Information Only Service Note

Supersedes:
3070-104

E9905G-AS2 Convert system for Asynchronous 2 modules
E9905G-AS3 Convert system for Asynchronous 2 modules activation
E9905G-KC1 Hardware for Regional Specific Requirement
E9903G-KC1 Hardware for Regional Specific Requirement

Picture1: Yellow box indicates the position of the EMC covers in the accessory box.

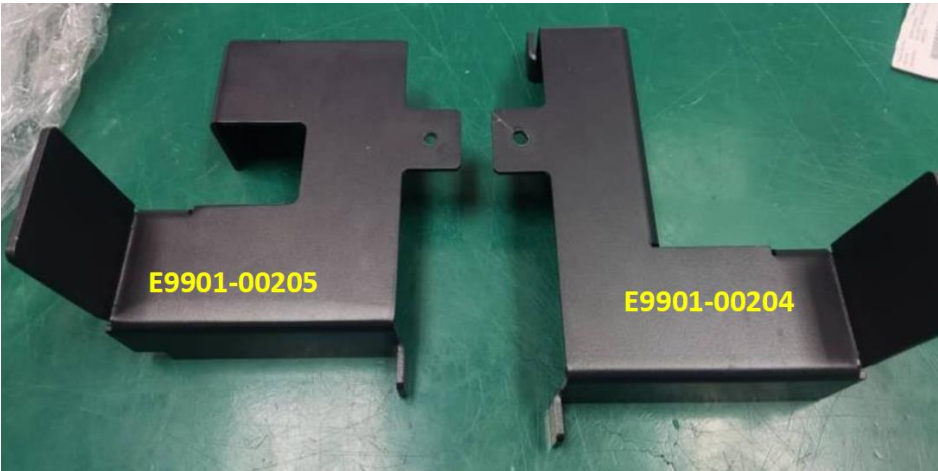
Factory installation of EMC covers E9901-00204(Right Bottom Cover – Bristol) and E9901-00205(Left Bottom Cover – Bristol) will obstruct the access to the M8 screw that secure the Testhead from moving during shipment. As such, both E9901-00204 and E9901-00205 will not be pre-installed at factory before shipment.

EMC covers E9901-00204and E9901-00205 will be packed into accessory box for shipment.

Picture3: Installation of E9901-00205 and E9901-00204

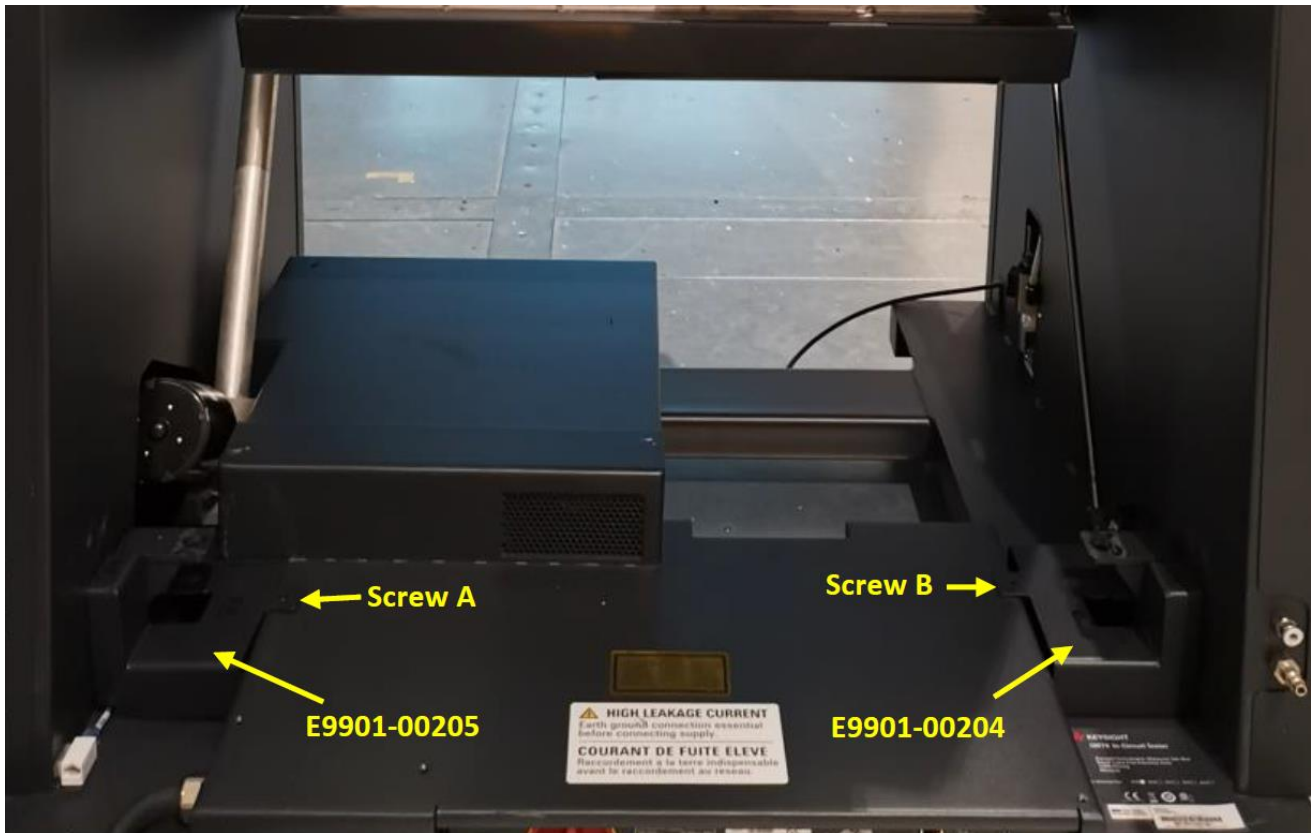
Field support engineer is required to install the covers after removing the M8 screw from the Testhead after installation. Follow the instructions below to install the covers.

1. Remove the 2 pcs of M8 screws are removed from the Testhead.
2. Turn On the PDU and rotate the Testhead into service position.
3. Remove the screw A and B as indicate below.
4. Install E9901-00204 and E9901-00205 on the position shown in Picture3.
5. Secure with screw A and B accordingly. Installation is complete.
